SUBDIVISION / LAND DEVELOPMENT PLAN APPLICATION

PROJECT NAME (TO BE COMPLETED BY TOWNSHIP): Kia SD/LD

PRELIMINARY LAND DEVELOPMENT PLAN FOR KIA AUTO LEASING

The Plan proposes a 4,500 S.F. automobile leasing building and associated improvements to the undeveloped portion of the property.

PRELIMINARY LANDSCAPE PLAN

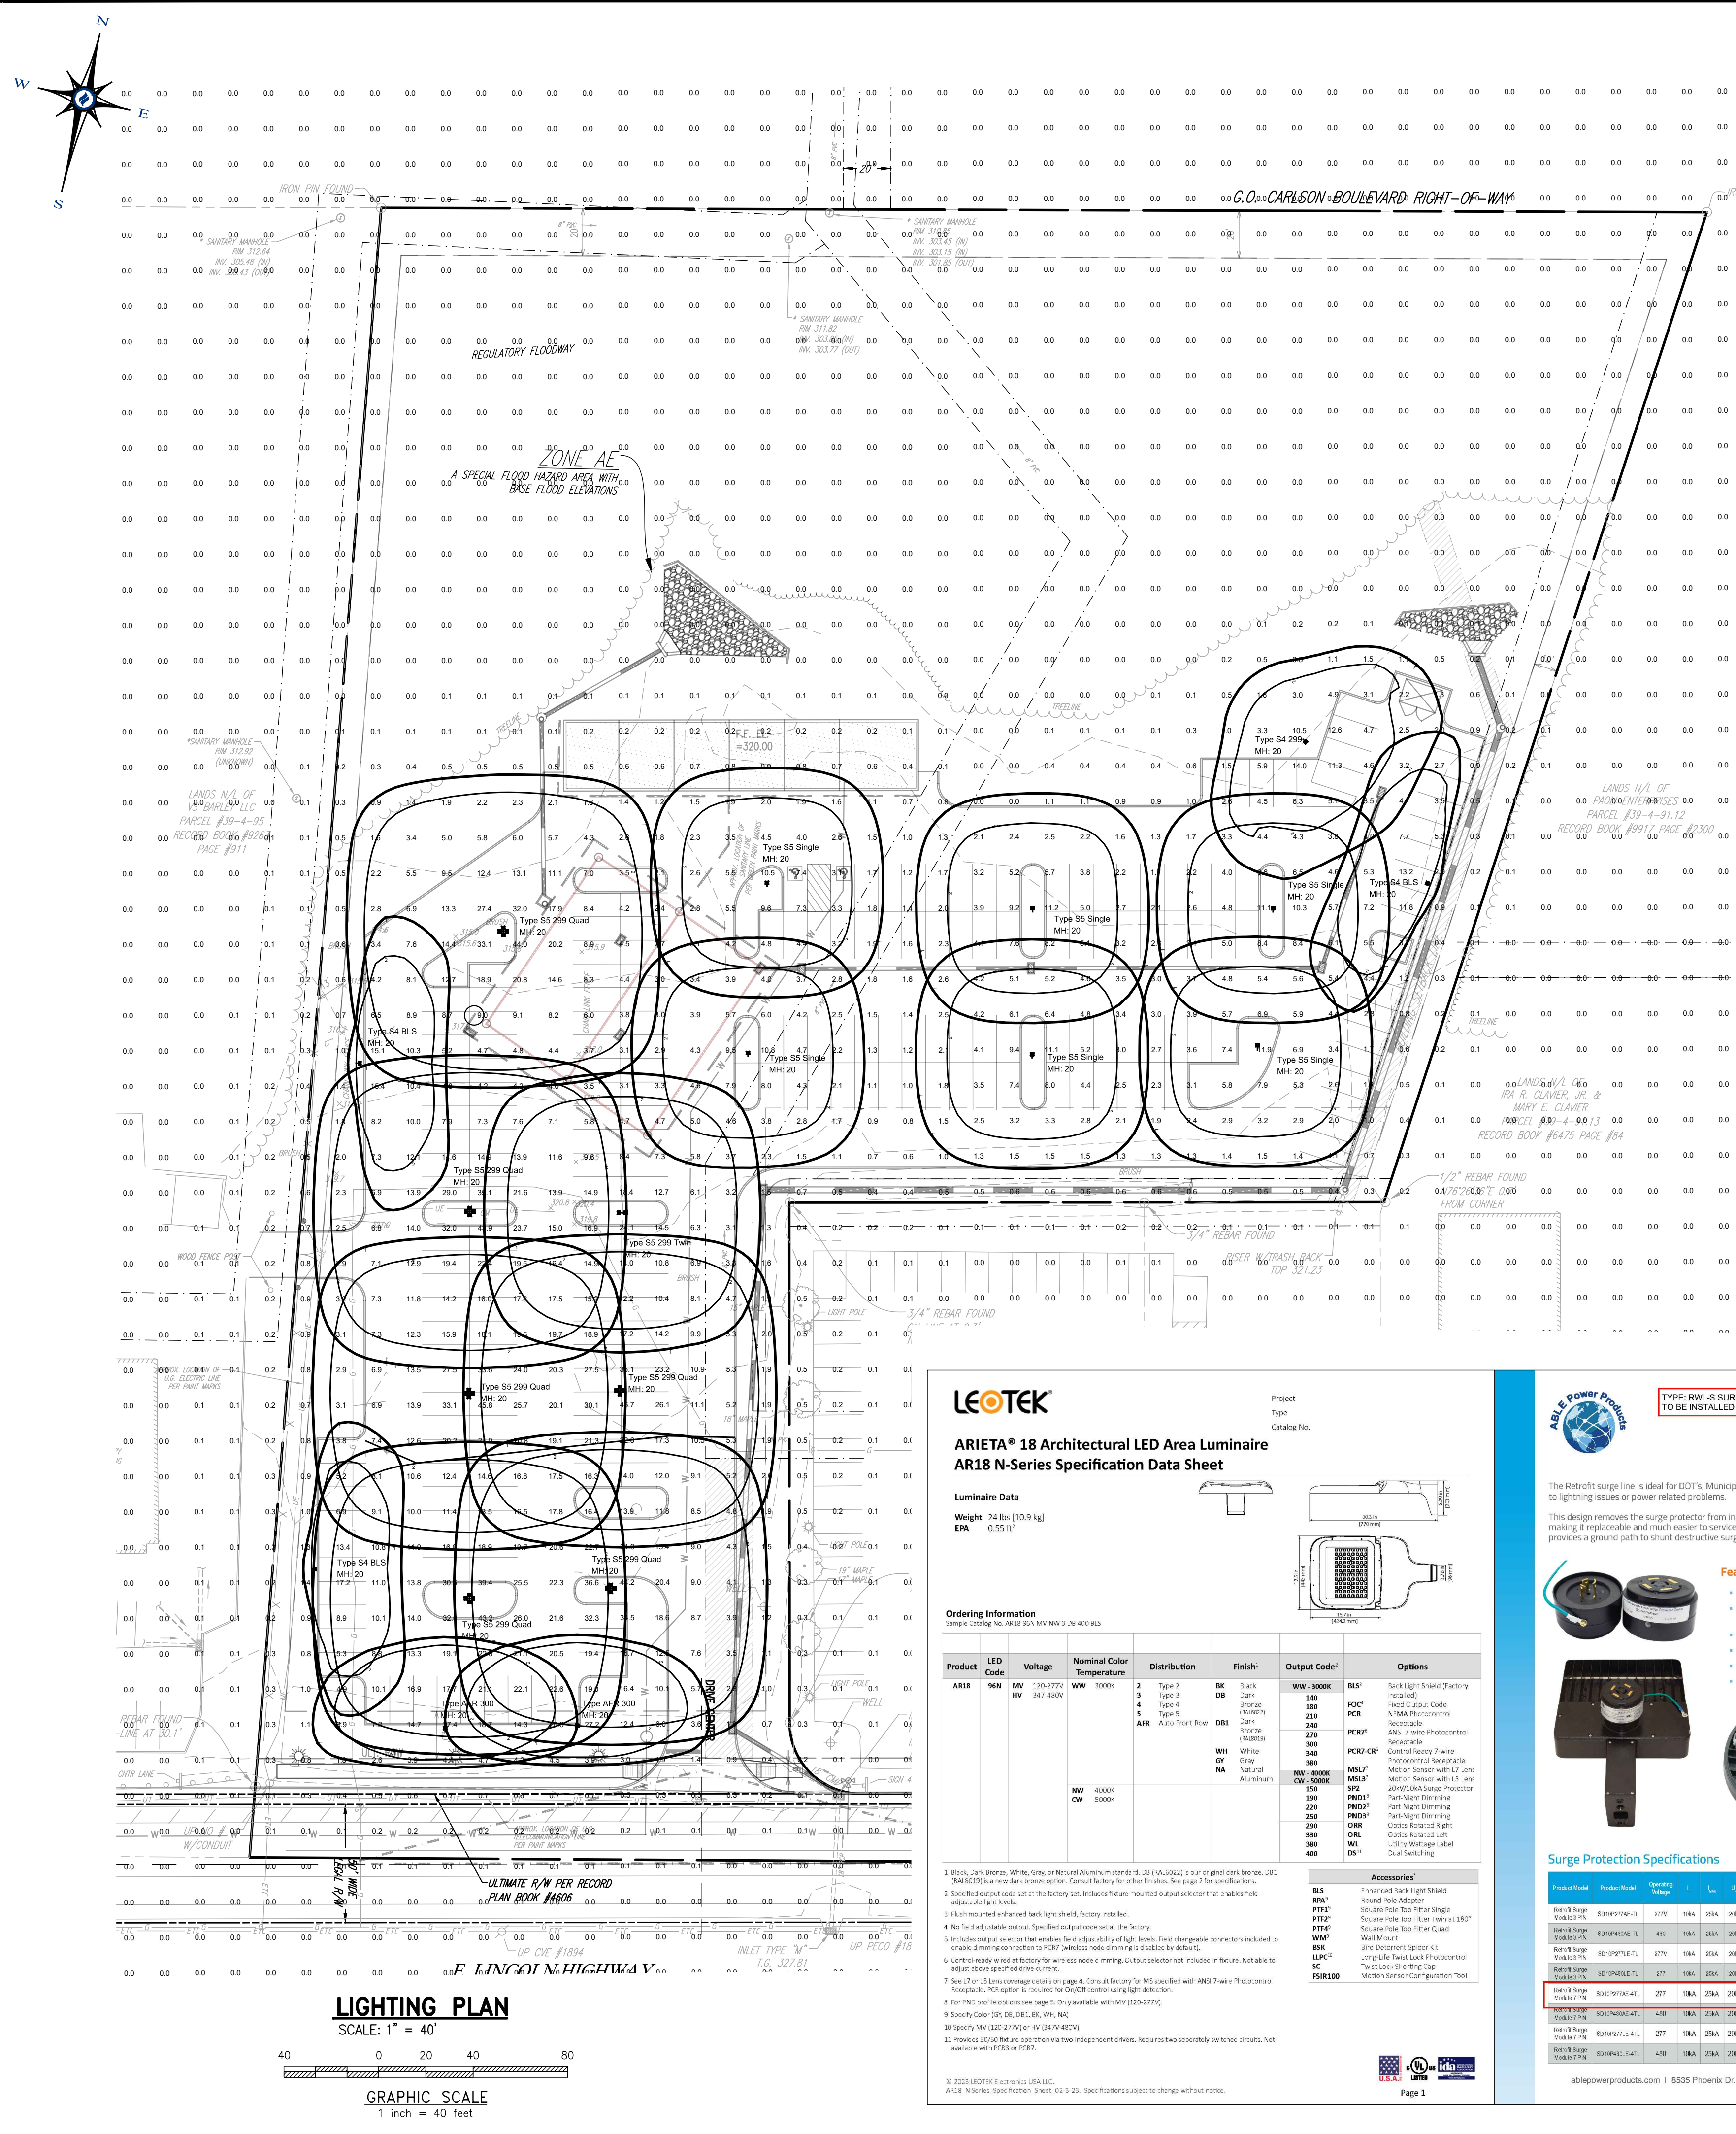
29. The proposed number of thornless honey locust trees appears to be inconsistent between the plan and plant list (on sheet 17).
30. The proposed number of arrow wood viburnum shrubs appears to be inconsistent between the plan and plant list (on sheet 17).
